Docket Item # 2
BAR CASE #2012-0198

BAR Meeting
July 11, 2012

ISSUE: Alterations (signage and ATM)

LOCATION: 277 South Washington Street

2
A4 **EXTERIOR ELEVATION: PROPOSED**
SCALE: 3/16" = 1'-0"

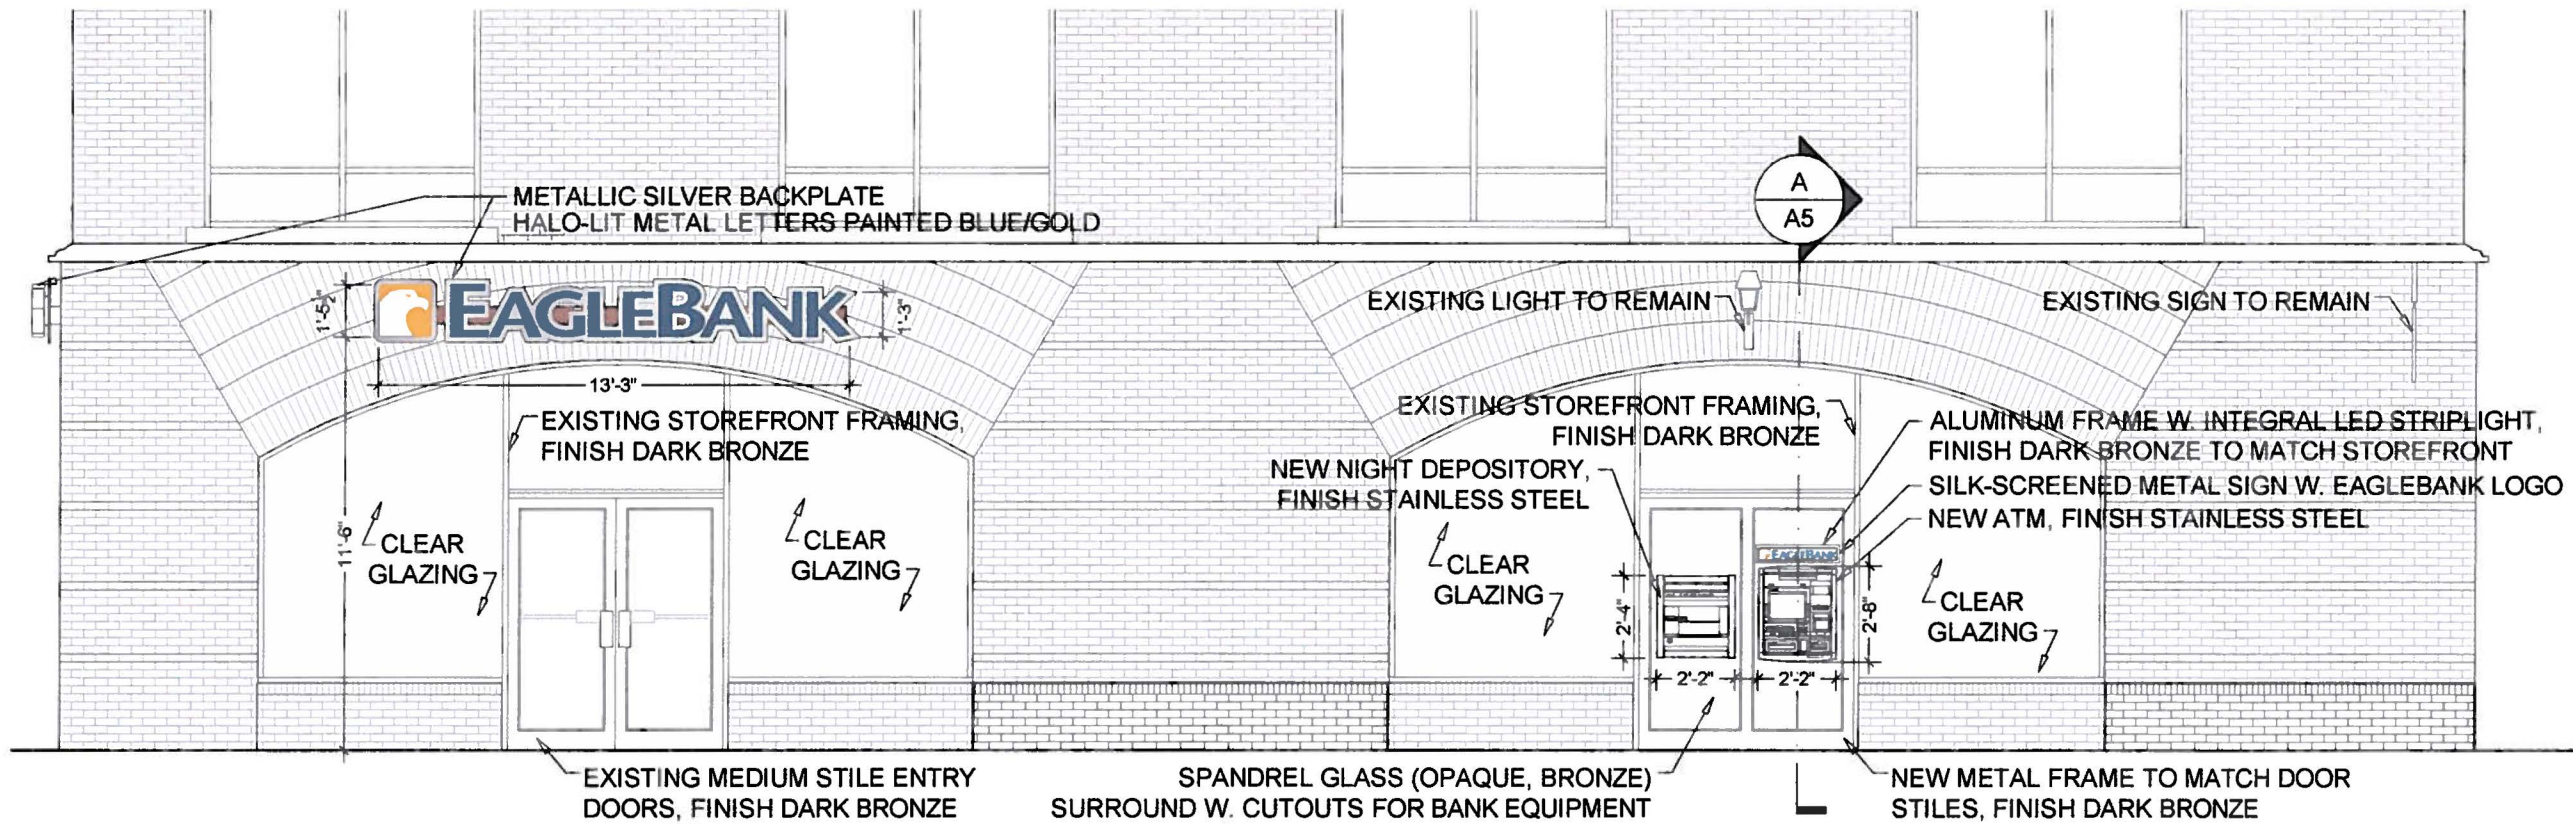
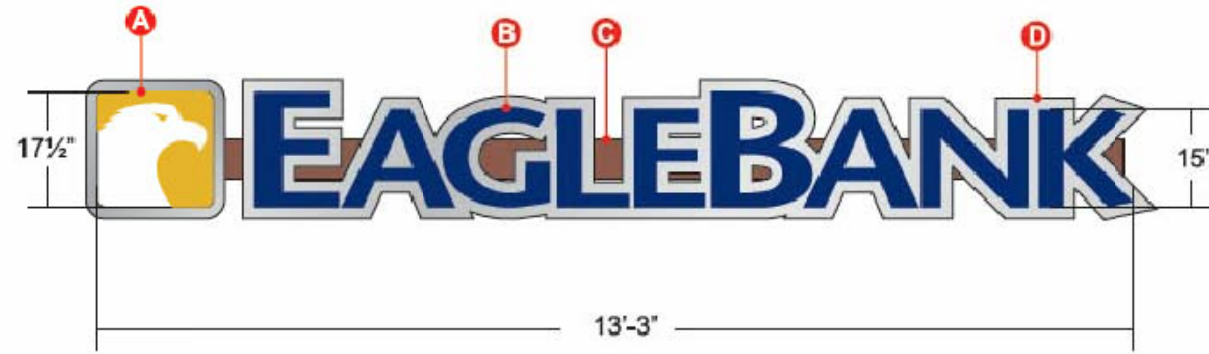
It is important to note that the National Park Service reviewed this application and recommended that the applicant examine moving the ATM and other improvements to the second doorway on the right of the entrance over to the Duke Street side of the building. NPS suggests keeping the four archway entrances along the Washington Street side more uniform to decrease the visual clutter.

Our comment on this project is that given one of our main goals is to clear Washington Street of visual clutter - has the applicant examined moving the ATM and other improvements to the second doorway on the right of the entrance over to the Duke Street side of the building? We're aware that the building is modern, but keeping the four archway entrances along the Washington Street side more uniform would certainly decrease the visual clutter

BAR staff fully supports the Park Service's effort to reduce visual clutter on the Parkway at every opportunity and has supported putting the ATM on side elevations in the past, such as the Wells Fargo on N. Washington St. However, in this case the Duke Street elevation is set well back from the street behind a landscape terrace and trees and, as is evident in the applicant's photos, is not visible enough to insure public safety at night while using the ATM. For this reason, Staff supports the modestly sized ATM proposed on the Washington Street frontage if the light level is kept to the minimum necessary, to be confirmed with Staff in the field.

**HALO LIT CHANNEL LETTER
INSTALLATION DETAIL**

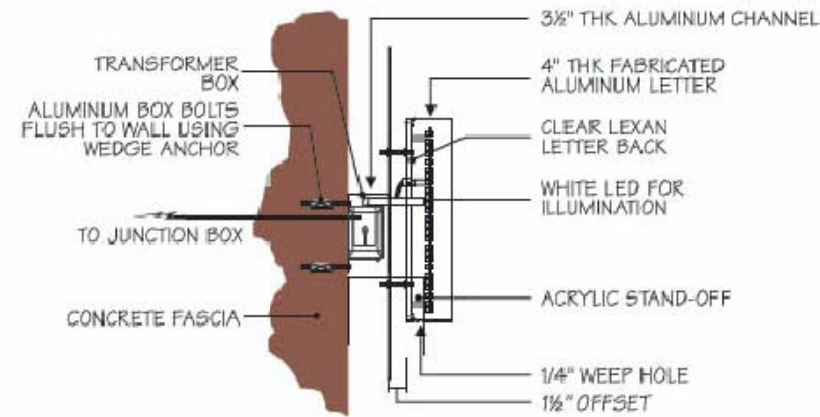
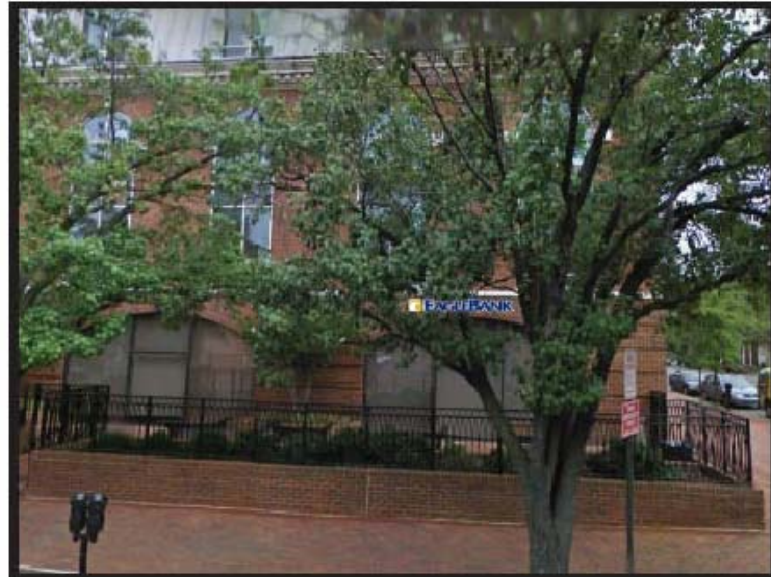
1. That the proposed back plate not be a reflective silver and have a matte finish instead.
2. That the LED light strip for both the ATM and the wall signs be installed with dimmers with final illumination level to be approved by Staff in the field.

However, with respect to the proposed back plate, off of which the halo illumination will reflect, Staff is concerned with the architectural character of the reflectivity of the proposed metallic silver finish on the back plate. The BAR had expressed similar concerns while reviewing the recent Burke & Herbert Bank signs and these surrounds were later muted by the applicant. Staff can support the use of a back plate but only if it has a neutral color with a matte finish and if the LED lighting level is approved by Staff in the field using a sign mock-up or on the installed signs using dimmers, as is the Board's standard condition for this new lighting technology.

1
A7 SECTION @ ATM: PROPOSED
SCALE: 1" = 1'-0"

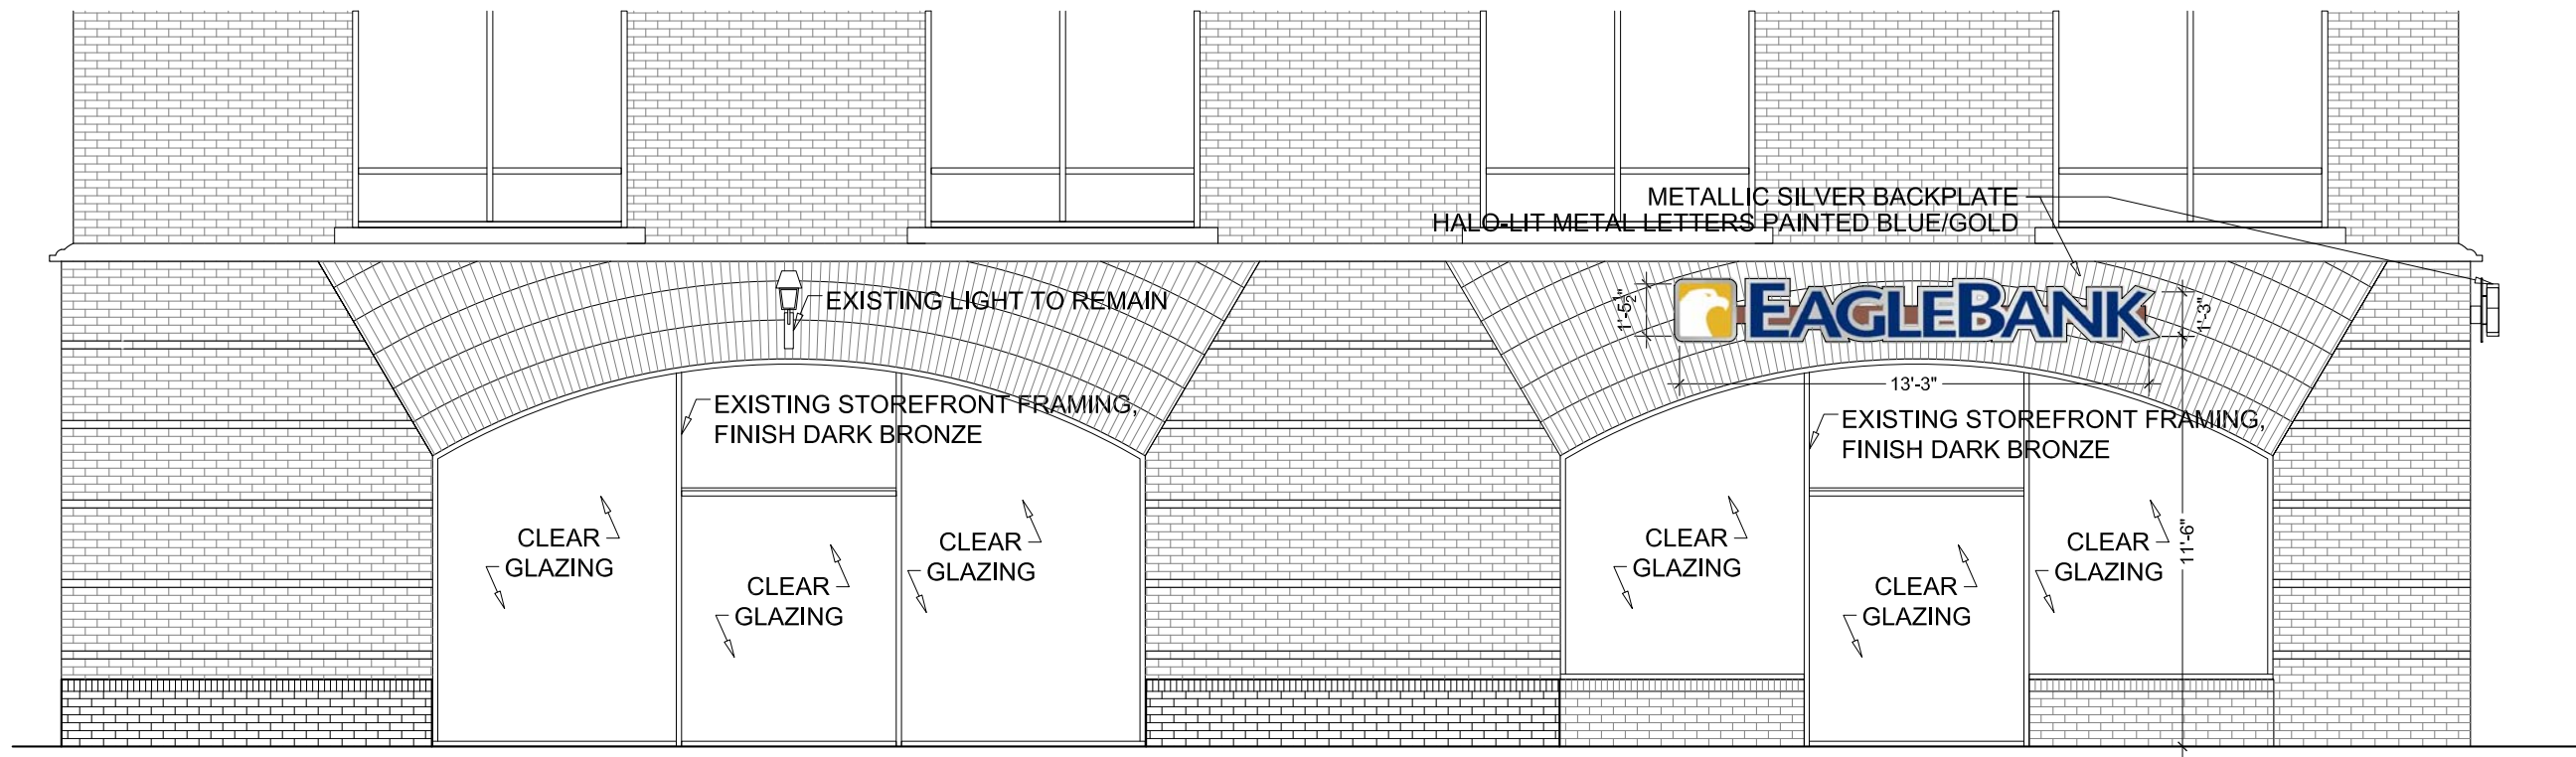
above the ATM is appropriate with respect to size and Zoning Ordinance requirements. In order to minimize excessive illumination, Staff recommends that the LED strip lighting at the ATM be installed with an adjustable dimmer and that the final approval of lighting levels be determined in the field.
